UNITED STATES  
DEPARTMENT OF THE INTERIOR  
BUREAU OF LAND MANAGEMENTFORM APPROVED  
OMB NO. 1004-0137  
Expires: January 31, 2018**SUNDRY NOTICES AND REPORTS ON WELLS**  
**Do not use this form for proposals to drill or to re-enter an abandoned well. Use form 3160-3 (APD) for such proposals.**5. Lease Serial No.  
NMSF078999

☐ Oil Well ☐ Gas Well ☒ Other: COAL BED METHANE8. Well Name and No.  
SAN JUAN 31-6 UNIT 220

**HILCORP ENERGY COMPANY**  
**SAN JUAN 31-6 UNIT 220 POW**  
**P&A NOI**

Re: Permanent Abandonment  
Well: San Juan 31-6 Unit 220 API: 30-039-24987

SAN JUAN 31-6 UNIT 220 POW - PROPOSED WELLBORE SCHEMATIC

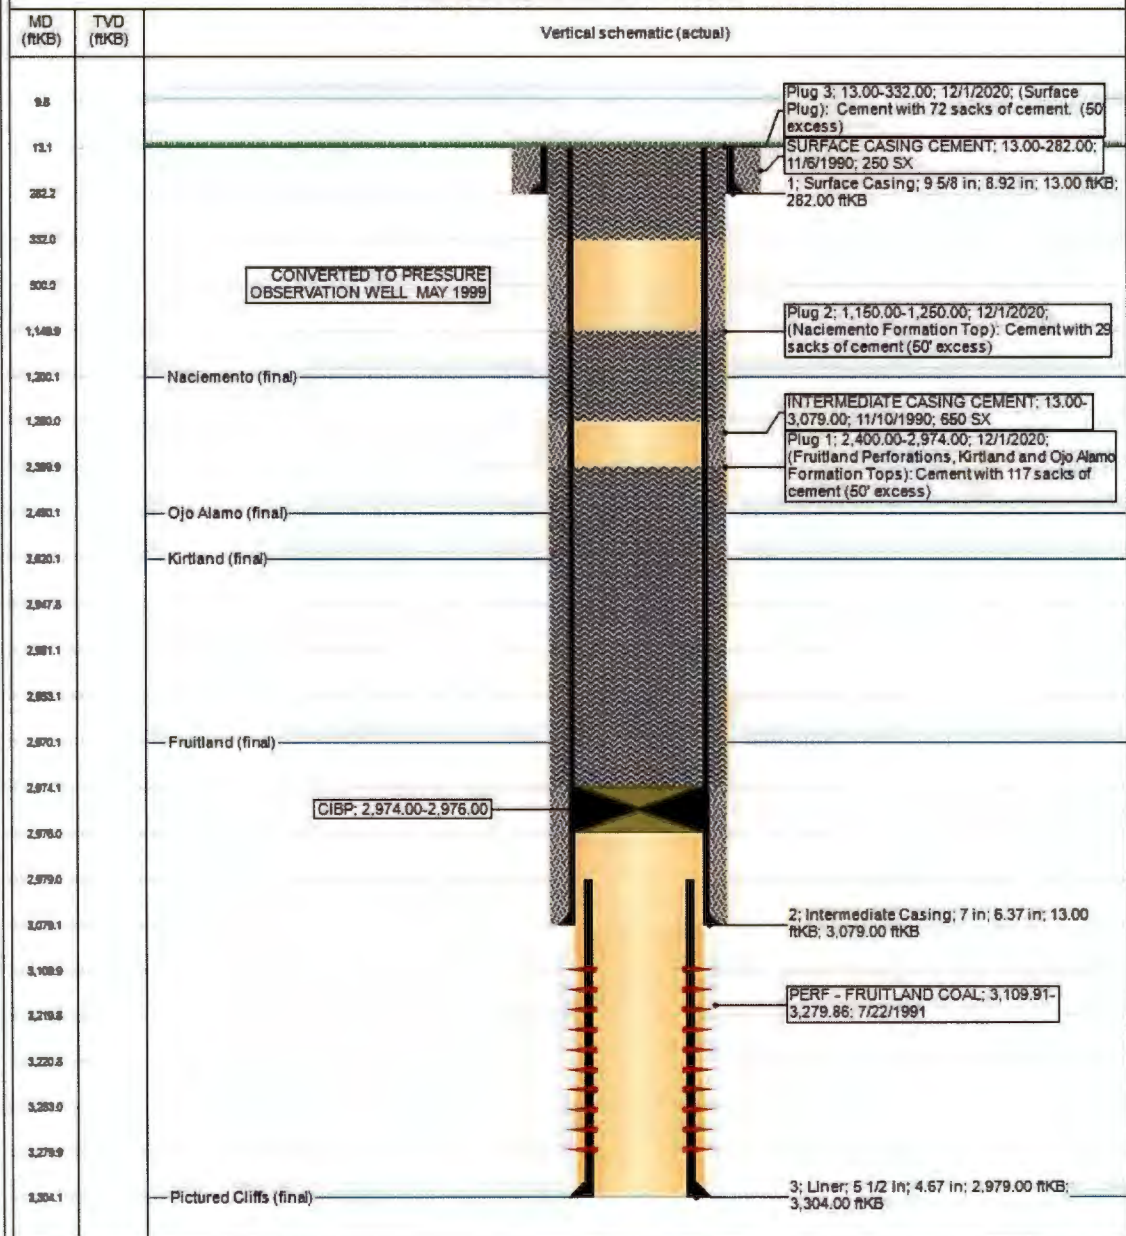
1. Plugging operations authorized are subject to the "General Requirements for Permanent Abandonment of Wells on Federal and Indian Lease."
2. Farmington Office is to be notified at least 24 hours before the plugging operations commence (505) 564-7750.
4. BLM picks formation tops as indicated in the table below for use in determining TOC for all plugs:

<u>Top</u>
Nacimiento	1200
Ojo Alamo	2450
Kirtland	2620
Fruitland	2970
Pictured Cliffs	3304

5. Surface plug: perforate and circulate cement.

- Log analysis of reference well #2 (attached worksheet) indicates the Nacimiento and Ojo Alamo sands investigated contain fresh water ( $\leq 5,000$  ppm TDS).
- Please ensure that the tops of the Pictured Cliffs, Fruitland, and Nacimiento Formations, as well as the entire Ojo Alamo fresh water aquifer identified in this report are isolated by proper placement of cement plugs. This will protect the fresh water sands in this well bore.
